## DEPARTURE REQUESTS

DEPARTURE EXHIBITS

D3 -- Code Compliant Example

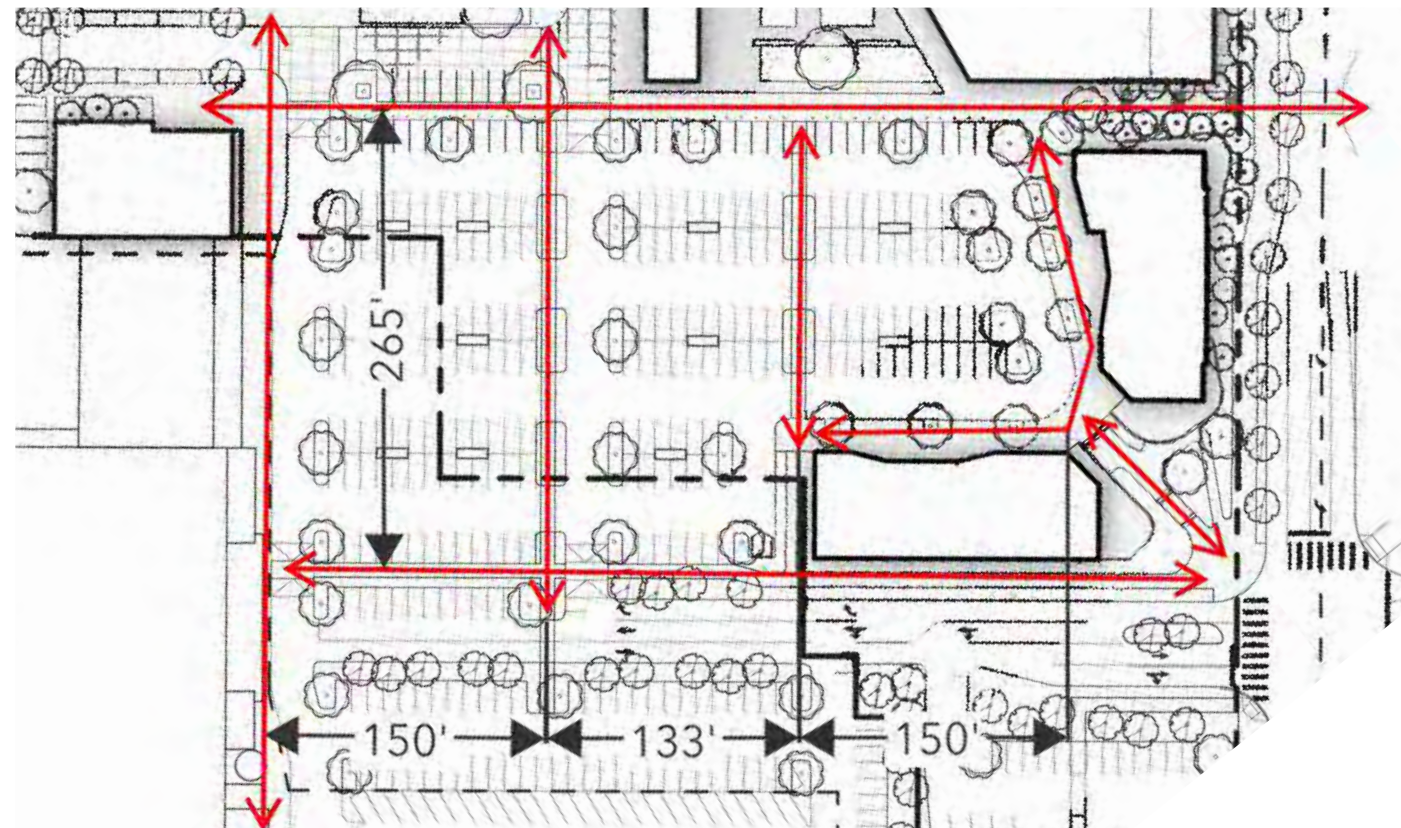
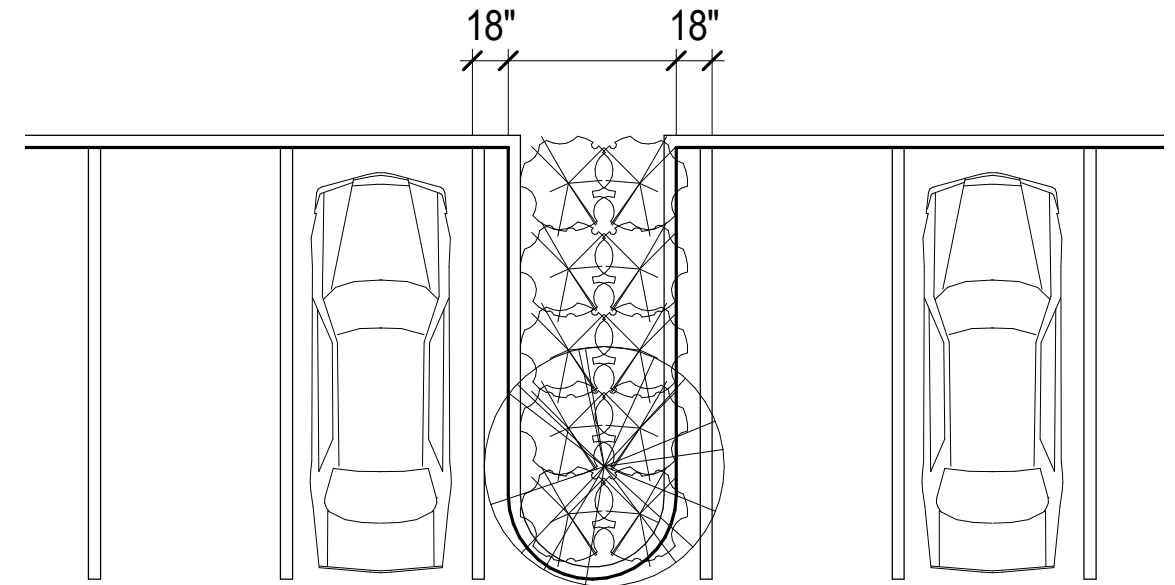
D2	20.50.240.E.1.a	Site Design - Internal Site Walkways	All development shall provide clear and illuminated pathways between the main building entrance and a public sidewalk. Pathways shall be separated from motor vehicles or raised six inches and be at least 8 feet wide	Allow for sidewalks along private residential streets and pathways not serving commercial uses to be reduced to 6 feet wide.	A 6' wide sidewalk along private residential streets with no commercial frontage would exceed the minimum 5feet wide sidewalk as required per. section 12.8 (Private Streets) of the Shoreline Engineering Manual.
D3	20.50.240.E.1.c	Site Design - Internal Site Walkways	Raised walkways at least eight feet wide shall be provided for every three, double-loaded aisles or every 200 feet of parking area width. Walkway crossings shall be raised a minimum three inches above drive surfaces	Allow for walkways to be provided for every 265 feet of parking lot width provided that no parking stalls is more than 100 feet from a walkway,	A parking lot with three code compliant double-loaded aisles exceed the minimum 200 feet aisle separation. The proposed site design creates a framework of well connected pedestrian scaled blocks that serves uses on multiple sides. The largest proposed distance between walkways is greater than 200 feet, however no stall is more than 100 feet from a walkway which is consistent with the intent of the code requirements.  <a href="#">Proposed Departure supported by Departure Exhibit D3</a>

D4 -- Code Compliant Example

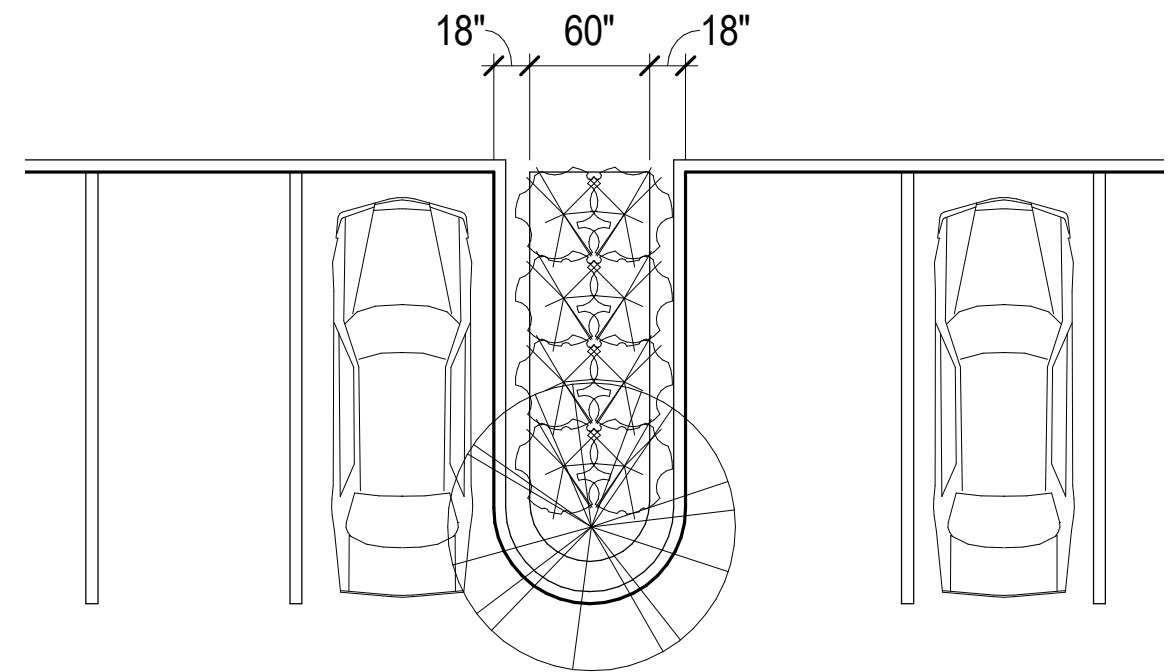
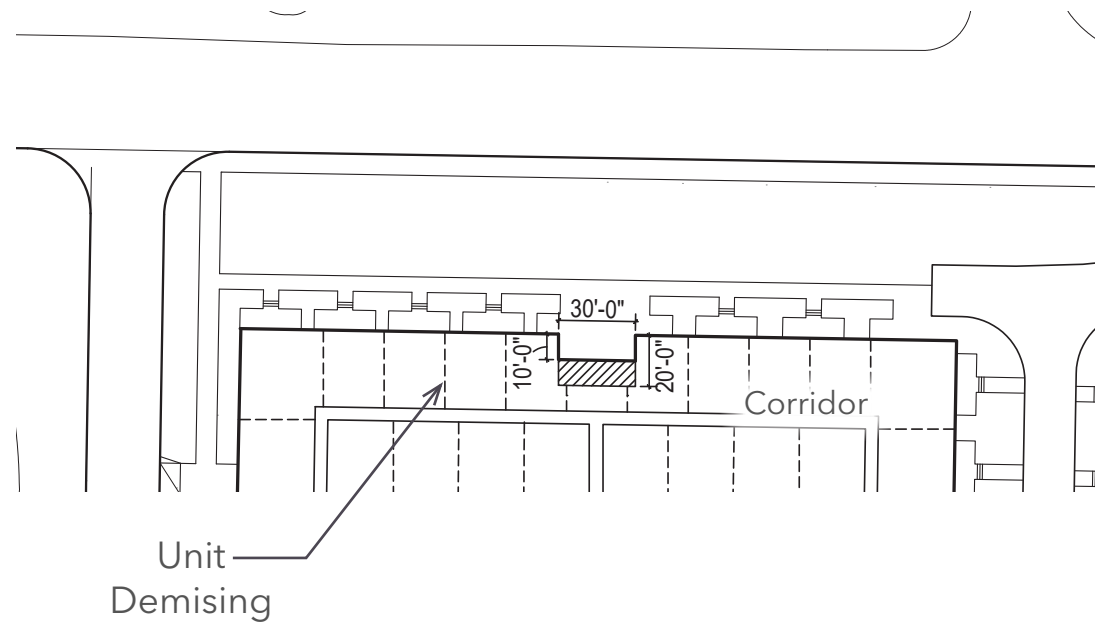
D4	20.50.410.H	Parking design standards	Parking spaces abutting a landscaped area on the shall provide an additional 18 inches to provide a place to step other than in the landscaped area. In a parking garage, any space abutting a wall shall provide an additional 18 inches.	Allow for the required 18" step-off to be provided with a 12" paving strip inside the 6" curb.	This departure would still achieve the goal of not requiring a driver or passenger to step into a landscape area, but onto a durable surface. This is the same condition that occurs at parallel street parking.  <a href="#">Proposed Departure supported by Departure Exhibit D4</a>
D5	20.50.410.F	Parking design standards	Stall size (width x length) to be: <ul style="list-style-type: none"> <li>Desired: 9' x 20'</li> <li>Minimum: 8.5' x 20'</li> <li>Compact: 8' x 16'</li> </ul> Note: up to 50% of stalls allowed to be compact stalls	Allow for the following stall sizes (width x length): <ul style="list-style-type: none"> <li>Desired: 9' x 18'</li> <li>Minimum: 8' x 16'</li> <li>Compact: 7.5' x 15'</li> </ul> Note: up to 50% of stalls allowed to be compact stalls	The site design recognizes that transient users require larger parking stalls due to the higher turn-over rate. With this in mind, the site plan includes a combination of 9'x 20' and 9' x 18' commercial stalls with a less than 25% of stalls being 9' x17'. Smaller stall sizes, specifically within residential buildings are more consistent with the urban character of the development and the goal of increasing land efficiency as outlined in the CRA.

D8 --- Departure Request --- Plan

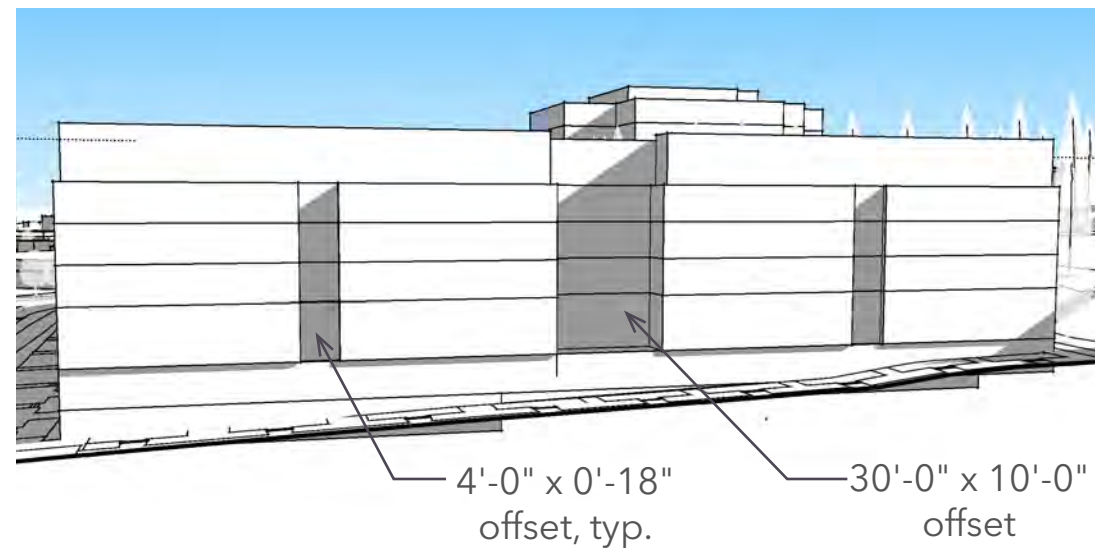
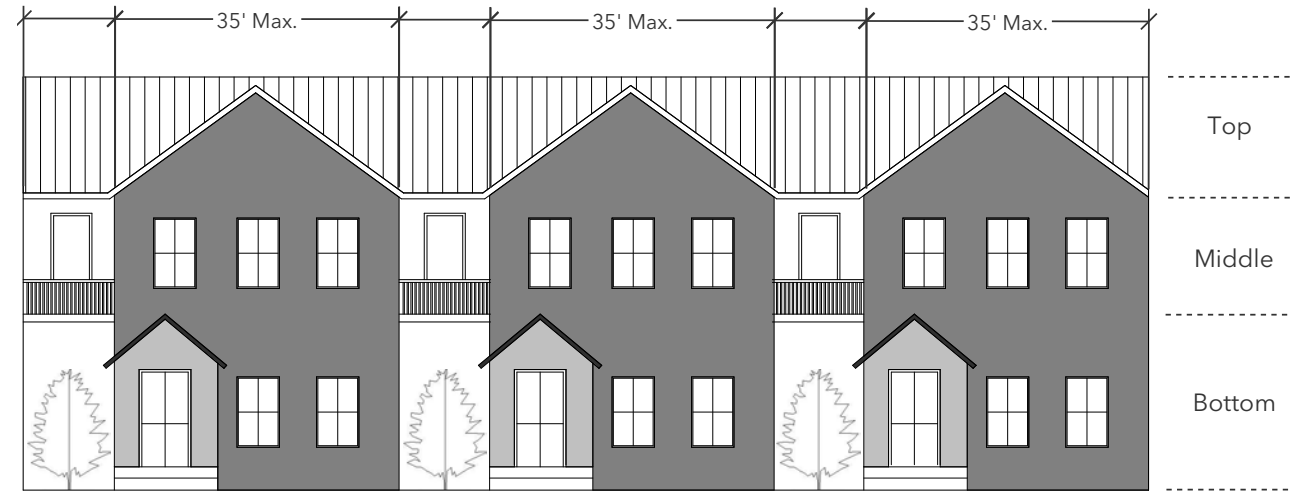
D8	20.50.250.B.5	Building Design - Building Articulation	Every 150 feet in building length along the street front shall have a minimum 30-foot-wide section that is offset by at least 20 feet through all floors.	Every 150 feet in building length along the street front shall have a minimum 30-foot-wide section that is offset by at least 10 feet through all floors above the ground level floor.	Extending the required building articulation down to the ground level interrupts the consistency of the urban street frontage. A departure from this requirement would enhance the ground level experience as envisioned in the Aurora Square CRA.  <a href="#">Proposed Departure supported by Departure Exhibit D8</a>
